Application for DCO by FOSSE GREEN
Representation by Interested Party reference [REDACTED]
Deadline 2

Comments on REP1-047 Applicant's response to Written Representations

Figure 1 of the EPRI “Insights from BESS failure incidents database: Analysis of failure root cause”

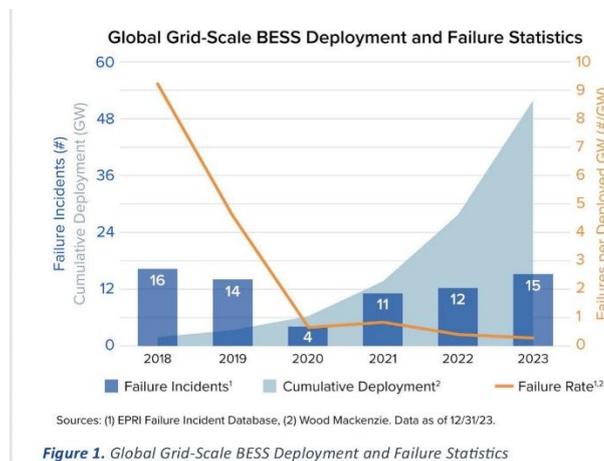
9.2.1 The figures quoted above by the Applicant are taken from the EPRI “Insights from Battery Energy Storage Systems (BESS) Failure Incident Database: Analysis of Failure Root Cause” and based on Figure 1 of the paper:-

9.2.2 The Applicant suggests that the BESS failure rates as a proportion of BESS deployment has sharply decreased as the BESS technology has matured. However, if the years 2018 and 2019 are discounted (when the technology is less well advanced) the failure rate from 2020 onwards is on a far less steep downwards trend. EPRI acknowledge that not all of the BESS failures are included in their database, for example the Aberdeen fire in 2025 is not included. The EPRI database shows 8 BESS failures in 2024 and 13 BESS failures in 2025. Regardless of the root cause of the BESS failures, a BESS fire/explosion can have potentially devastating consequences.
